Prairie Island Nuclear Generating Plant Units 1 and 2
Dockets 50-282 and 50-306
License Nos. DPR-42 and DPR-60

Responses to NRC Requests for Additional Information Dated February 20, 2009 and
Follow Up Questions Regarding Application for Renewed Operating Licenses

Enclosure 1
NSPM Responses to NRC Requests for Additional Information
Dated February 20, 2009

Prairie Island Unit 1 Cumulative Heatup and Cooldown Cycles

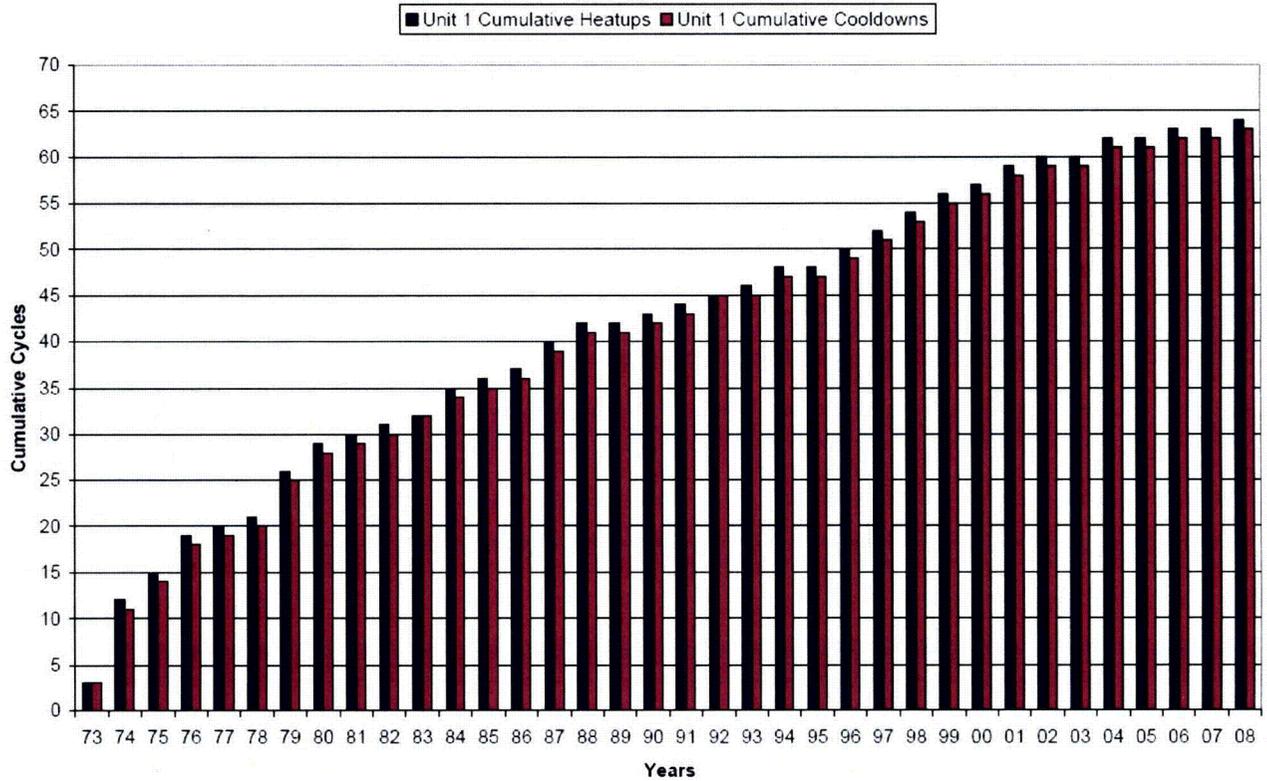
- (a) Please describe the procedures that PINGP has been using for tracking thermal activities so the staff can confirm that the PINGP aging management program will ensure that P-T characteristics, including their values, ranges, and rates remain bounded within the range defined in the design specifications during the renewed license term.
- (b) Please provide a histogram (cycle accumulating charts) of heatup transient history, and a histogram for the cooldown transient as well.

Histograms showing the cumulative number of heatup and cooldown cycles for PINGP Units 1 and 2 through 2008 are provided below. Since both Units were operating at the end of 2008, the cumulative number of cooldowns for each Unit is one fewer than the number of heatups.
